GE Energy, Nuclear (GEEN)  
Global Nuclear Fuel (GNF)

BWR  
Control Rod Drop Accident  
(CRDA)

# BWR Best-Estimate CRDA Calculations

# BWR Best-Estimate Calculated CRDA Enthalpies

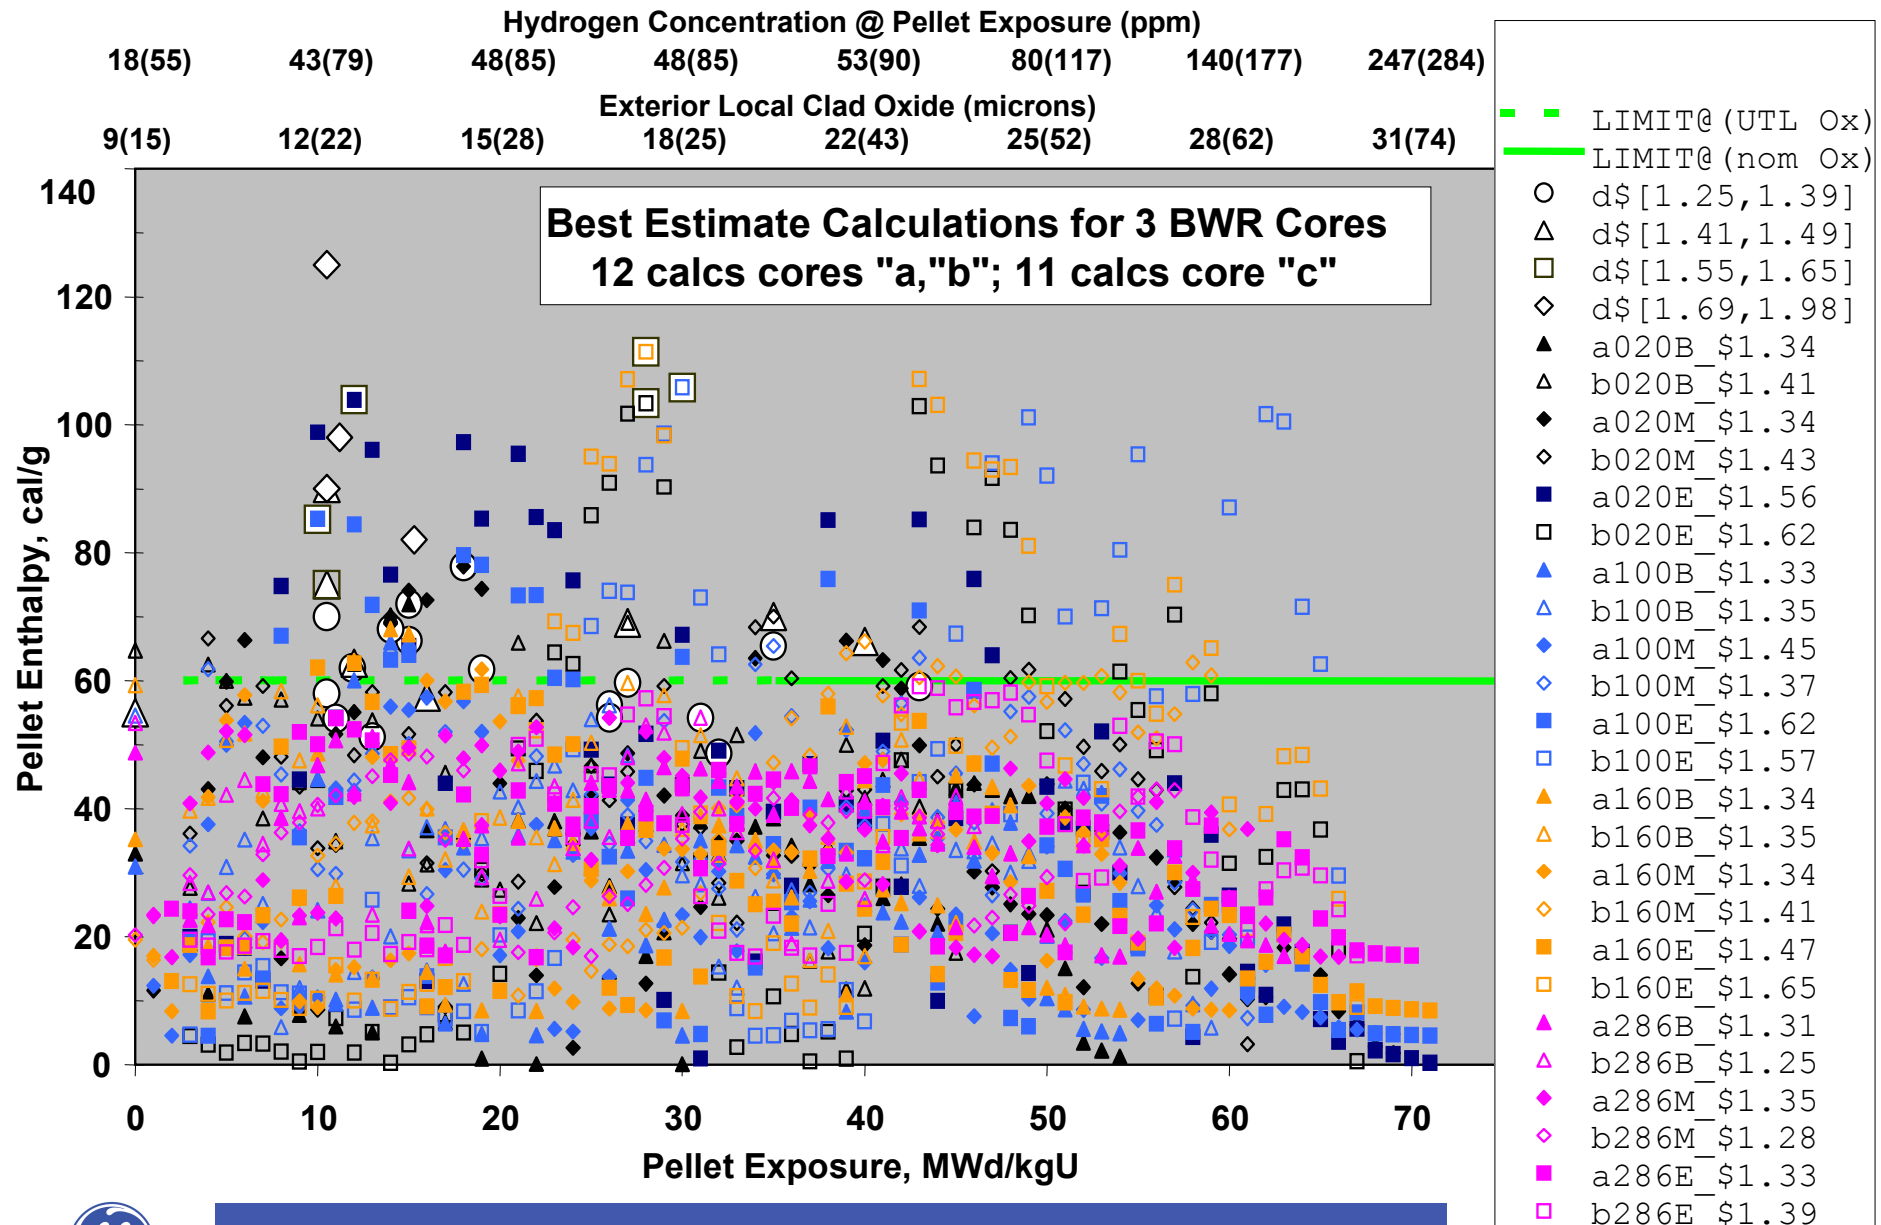
60 cal/gm at 20 microns is unworkable for BWRs.

# Conclusion from the BWR Best-Estimate CRDA Calculated Enthalpies versus Exposure

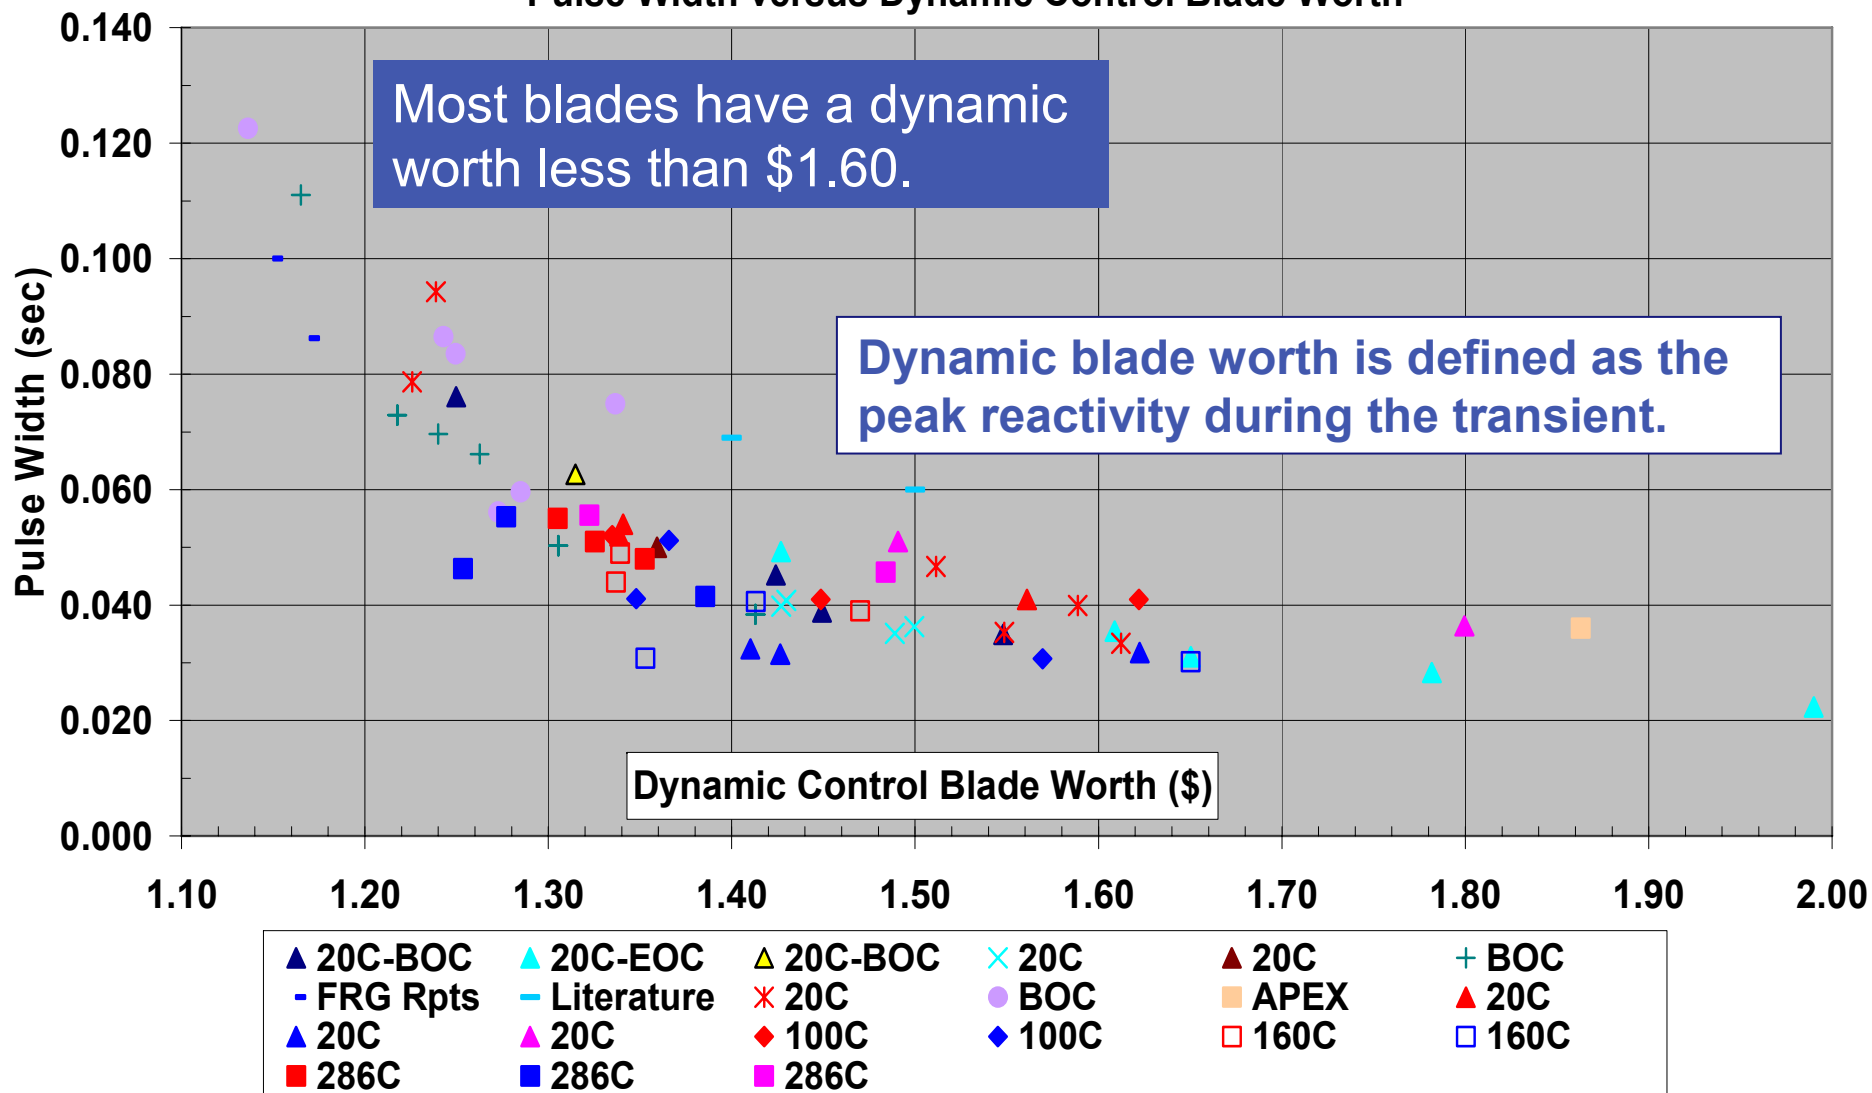
A limit of 60 cal/gm at 20 microns of oxide will make design of BWR cores impossible.

# Pulse Width Observations

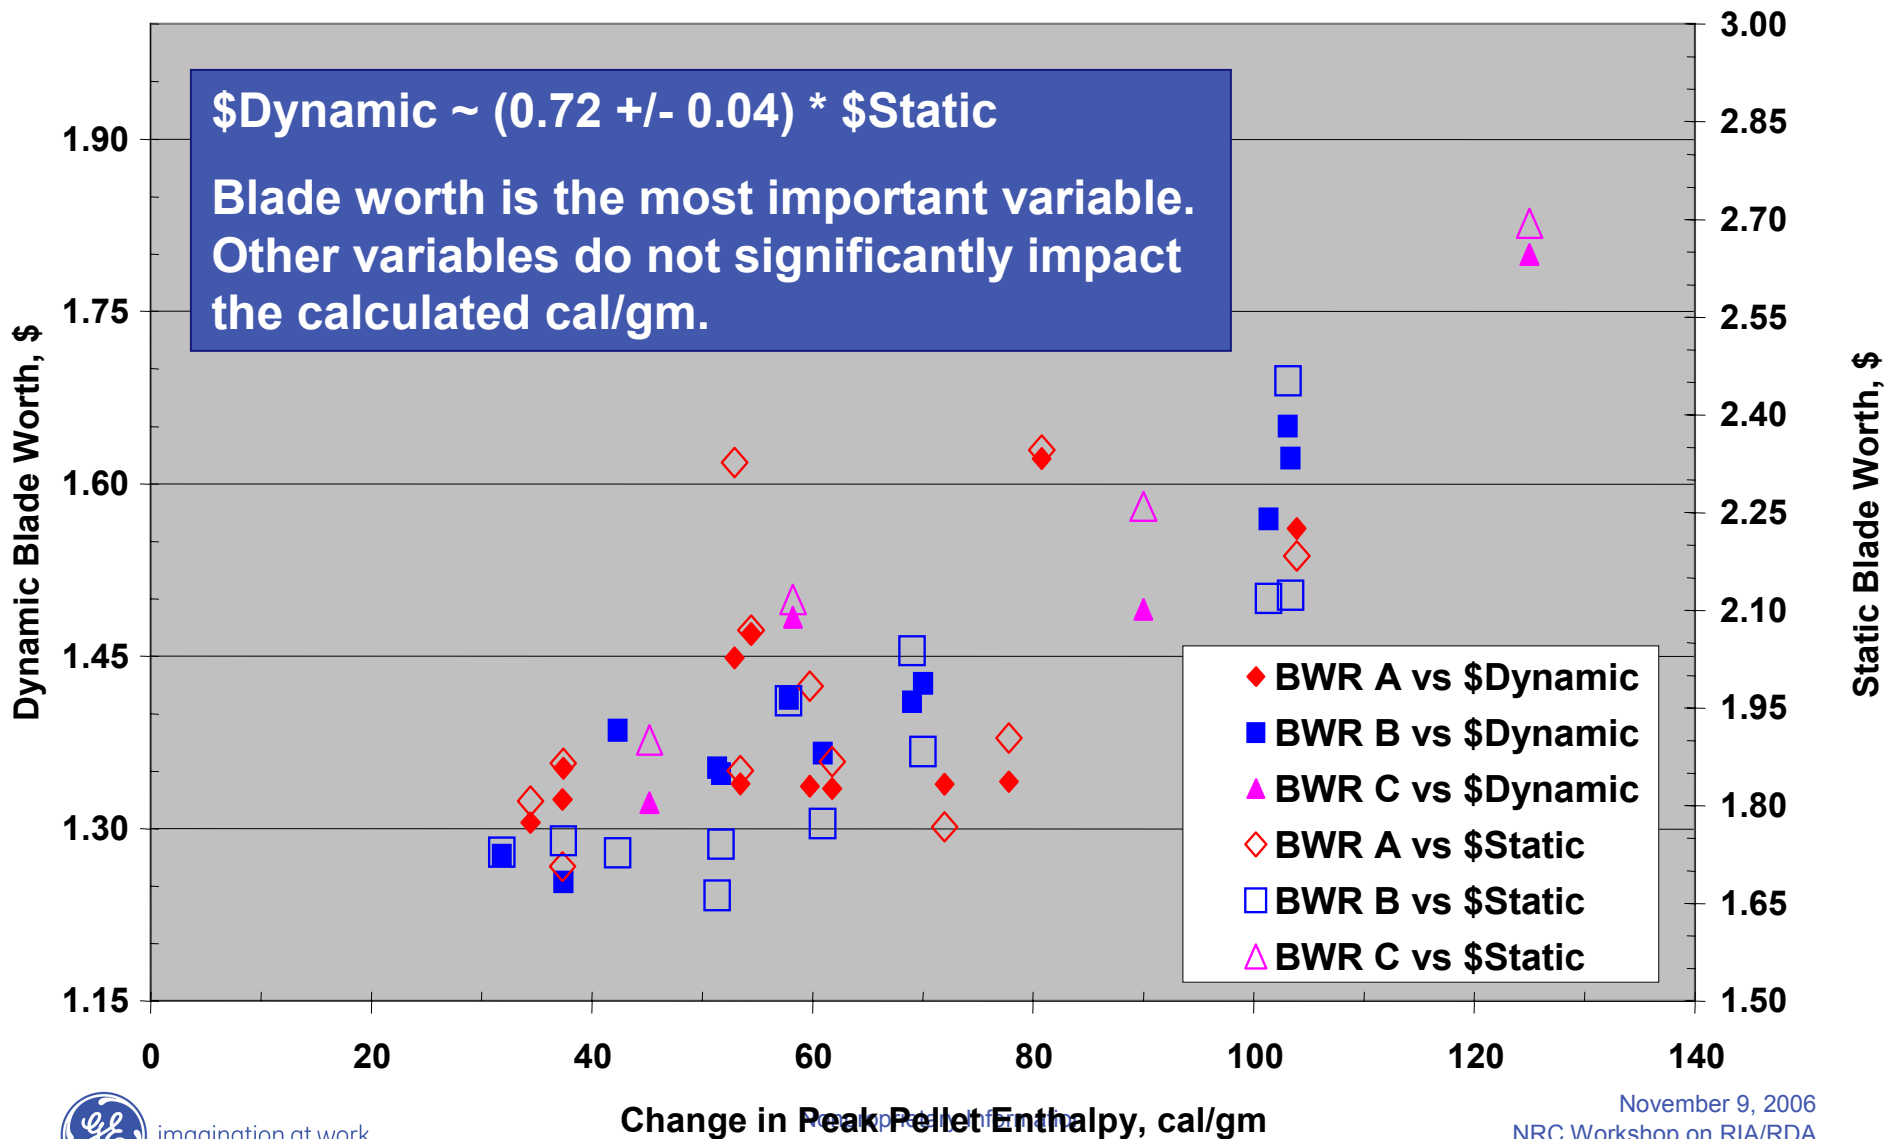
- BWR pulse widths are a function of the control blade worth and the fundamental nuclear characteristics of a BWR (i.e., fuel to moderator ratio) neither of which can be fundamentally changed without encountering other constraints such as thermal margins, peak clad temperature and shutdown margin.
- BWR Pulse Widths can be correlated to dynamic control blade worth.
- Results are remarkably consistent between different methods.

Even for very large control blade worths the pulse widths remain larger than 20 msec.

BWR pulse widths are substantially larger than for most experiments where cladding failures and fuel dispersal were observed.
